PJM Manual 01

Control Center and Data Exchange Requirements

Revision: [3029](#)

Effective Date: [December 18, 2014](#)

Figure 1: Telemetry Requirement for External Tie-lines

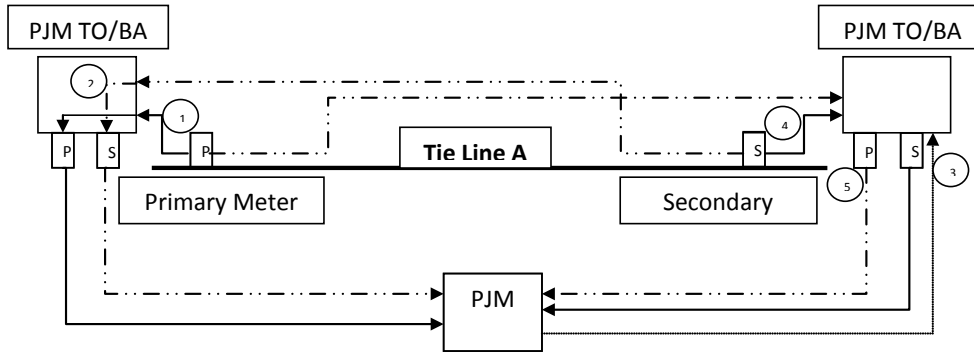
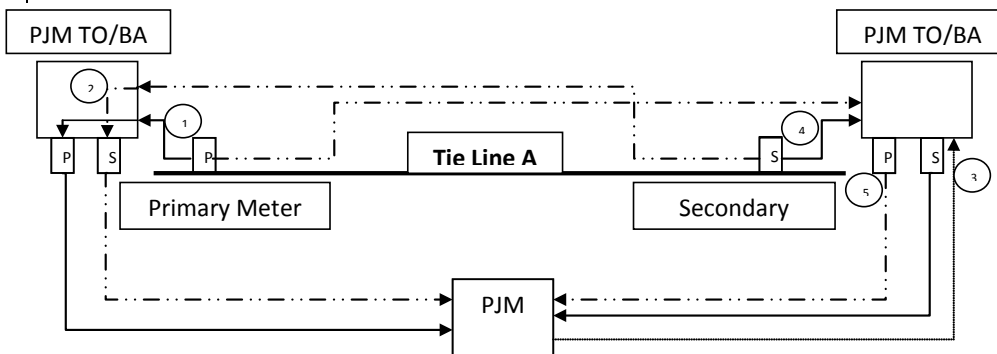
This section specifies the requirements for monitoring PJM tie lines with any neighboring external Balancing Authority (BA) (See Figure 1) and ties between Transmission Zones internal to PJM (See Figure 2). The Section 5.2.1.1 requirements apply to new tie line installations or upgrades to existing tie line installations.

Following are the telemetry requirements for monitoring PJM Ties with any neighboring external Balancing Authority (BA) (See Figure 1). These requirements are also applicable to ties defined between Transmission Zones internal to PJM (eg: AEP-DEOK etc.) (See Figure 2) This will apply to any existing tie-lines that get modified.
